DC/25 /1269—Rudgwick Parish Council (RPC) considers the proposal to install a Puffin Crossing as shown below, instead of an informal crossing point, a significant improvement. It also can see the sense in extending the proposed new pavement, directly fronting the A281, to both reach the Puffin crossing and site entrance. However it still has some related concerns that are outlined below.

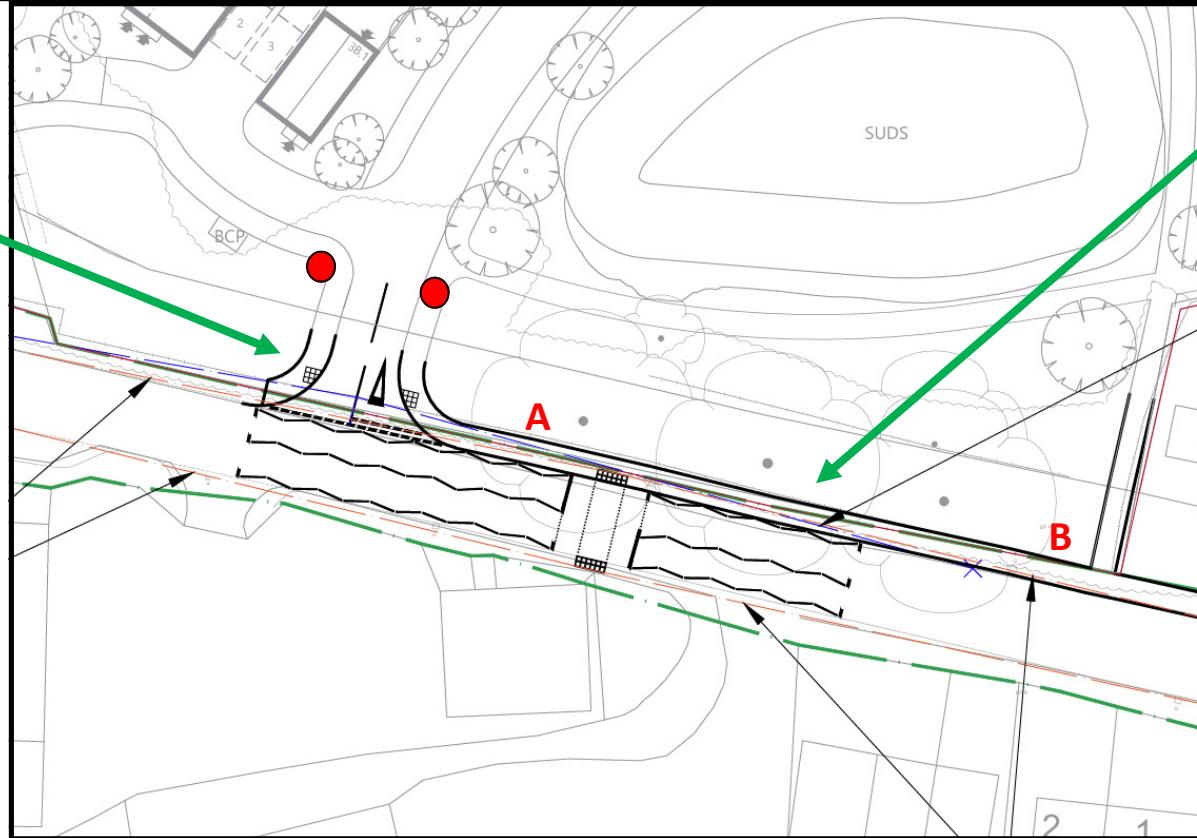
Informal Pedestrian crossing point at mouth of junction with A281 encourages pedestrians to cross at the most dangerous point.

Why not remove pavement on western side of site access road and have the informal crossing point further into the site at the points shown with a red circle? That way there is less immediate conflict with vehicles entering the site. Also it allows 2 or 3 vehicles to be waiting to exit the site and not to be an obstacle to pedestrians wanting to cross.

Pavement **A-B** now fully fronts the A281 and was not proposed with the original design. Whilst this is to be welcomed from a Road Safety aspect it does mean that there is more impact on 3 Category A2 trees (49-51-55) and hedgerow group G6.

The Arboricultural Impact assessment needs to be updated to ensure that this is recognised and suitably mitigated/compensated.
